**CITY OF RAMSEY LAND USE APPLICATION  
TECHNICAL REVIEW FILE**

<b>DATE</b>	MAY 26, 2017	<b>PROJECT ADDRESS</b>	7800 SUNWOOD DR NW
<b>PROJECT. TITLE</b>	STONEBROOK ACADEMY FINAL PLAT, PRELIMINARY PLAT, SITE PLAN REVIEW		
<b>ESCROW #</b>	115699		
<b>DEPARTMENT:</b>	Community Development: Planning Division (Zoning Code)		
<b>TECHNICAL REVIEWER:</b>	Name: Eric Maass, Consultant Planner Phone: 763-433-4302 Email: <a href="mailto:EMaass@wsbeng.com">EMaass@wsbeng.com</a>

**Preliminary and Final Plat Review**

<b>DATE</b>	MAY 23, 2017	<b>PROJECT ADDRESS</b>	SOUTH OF SUNWOOD DRIVE, WEST OF FUTURE YOLITE STREET
<b>PROJECT. TITLE</b>	STONEBROOK ACADEMY		
<b>ESCROW #</b>	115699		
<b>DEPARTMENT:</b>	Engineering		
<b>TECHNICAL REVIEWER:</b>	Name: Leonard Linton Phone: 763 433-9834 Email: llinton@ci.ramsey.mn.us

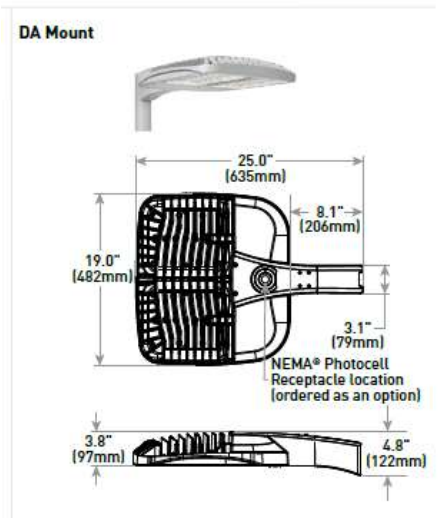
**Waste Storage:** Elevations provided show the trash enclosure to have an exterior finish of manufactured stone and EIFS that would match the primary structure as is required by the Design Framework, and Ramsey City Code.
